SUBJECT: Canadian Environmental Assessment Act (CEAA)
Screening Report, SkyTrain Extension Project

PURPOSE: To provide information regarding the CEAA Screening Report as requested by Council.

2.0 CEAA SCREENING REPORT

**Figure 1:
Diagrammatic SkyTrain Alignments Relative to Burnaby Stream Crossings**

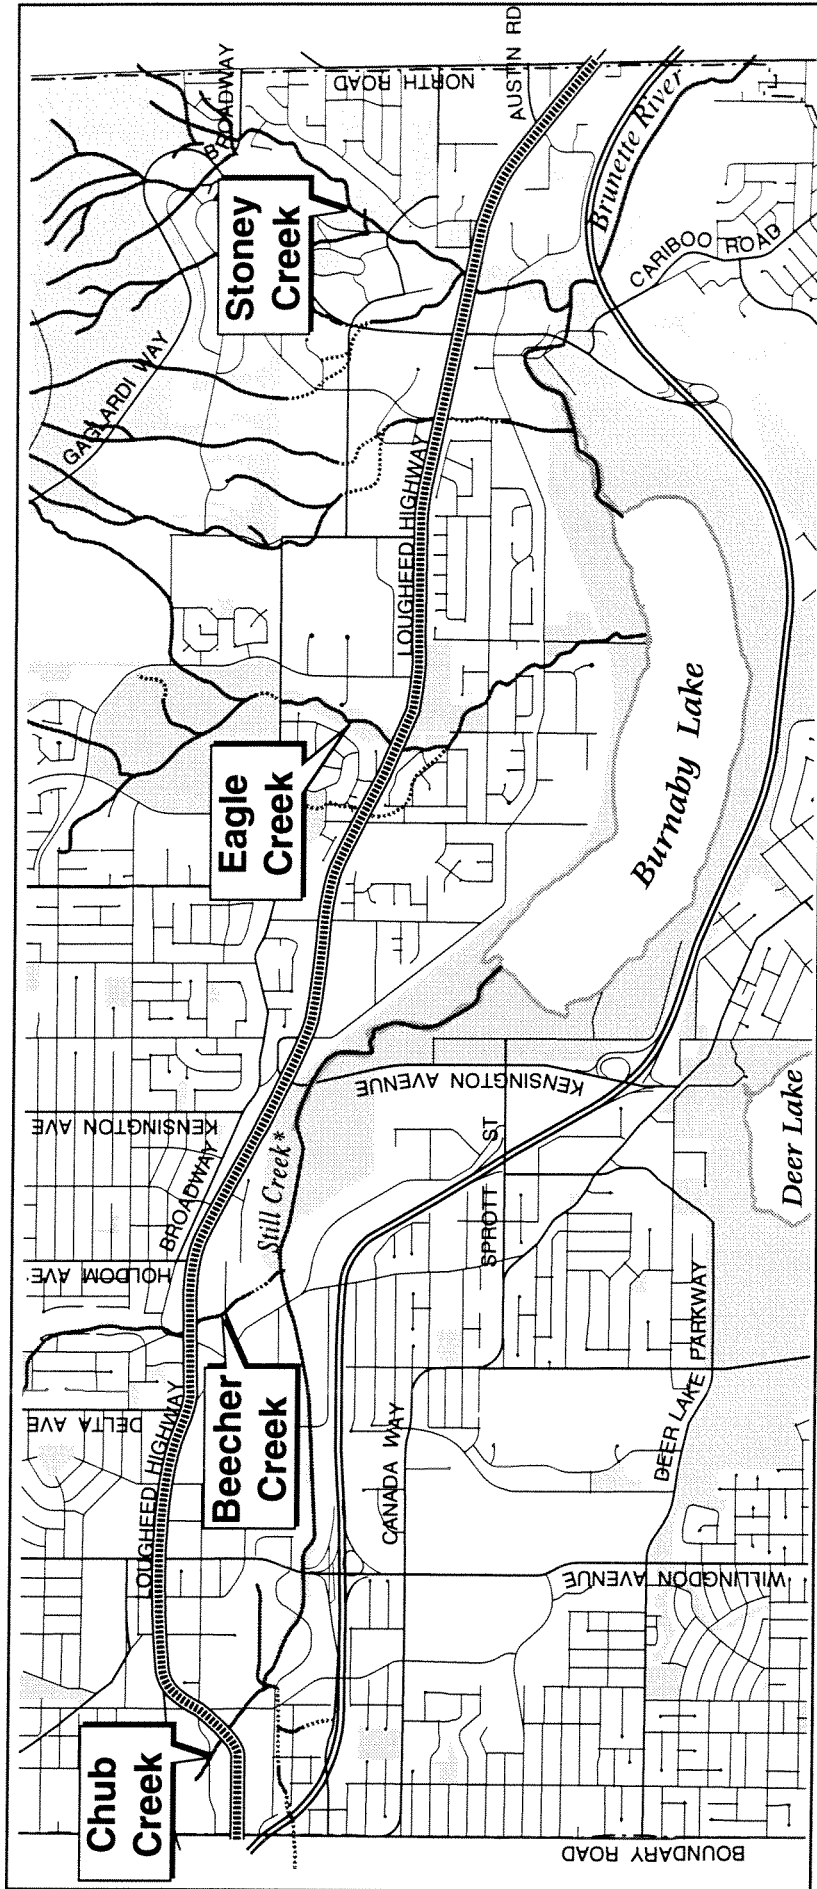
The extension of Skytrain in Burnaby will require crossings of Stoney Creek, Eagle Creek, Beecher Creek and Chub Creek as shown in Figure 1. Streams and riparian areas were recognized as the most sensitive areas from an environmental perspective and a number of measures by RTPO were identified to avoid, mitigate or compensate for any impacts to streams and riparian areas. The outcome of the CEEA Screening in regard to stream crossings follows:
